Re: St. Lucie Units 1 and 2
Docket Nos. 50-335 and 50-389
Response to Request for Additional Information Regarding License Amendment Request for Transition to 10 CFR 50.48(c) - NFPA 805 Performance-Based Standard for Fire Protection for Light Water Reactor Generating Plants (2001 Edition)

Enclosure 1**FPL's St Lucie Units 1 and 2 NFPA 805 LAR 60-Day RAI Response**

Figure 1. Damage rate – heat flux profile.

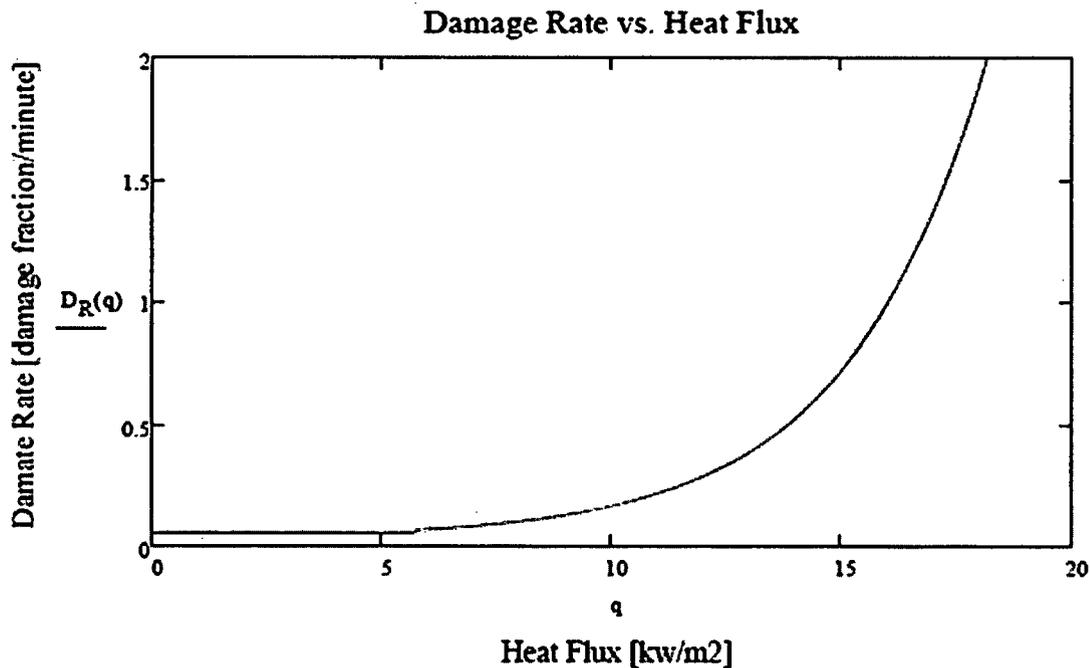
RESPONSE:

The methodology used in the LAR submitted FPRA model used a damage rate profile that assumed no damage before a critical incident heat flux was reached, directly applying the Appendix H data which states that no damage occurs prior to critical heat flux. The updated methodology that will be used to update the model will assume a damage rate equal to the critical heat flux damage rate for incident heat flux values up to and including the critical heat flux. This approach bounds any degradation of the cable target prior to the critical heat flux. Beyond the critical heat flux, the Arrhenius curve damage rates are applied with no maximum damage rate applied. This ensures the use of a bounding damage rate curve without extrapolating data to lower heat flux values, using the critical heat flux damage rate as a minimum damage rate, providing a

conservative, bounding analysis. Figure 1 below shows a plot of the damage rate – heat flux profile that models this approach.

Note: The above curve uses a profile more conservative than that specified in NUREG/CR-6850, Appendix H. Appendix H assumes no damage below the critical heat flux (the above curve assumes the rate of damage below critical heat flux is the same as at the critical heat flux). Appendix H also assumes a damage rate of 1/minute at a heat flux greater than 16 kW/m² (the above curve allows for application of higher damage rates above 16 kW/m²) as defined by the curve derived from the Appendix H, Table H-8 data.
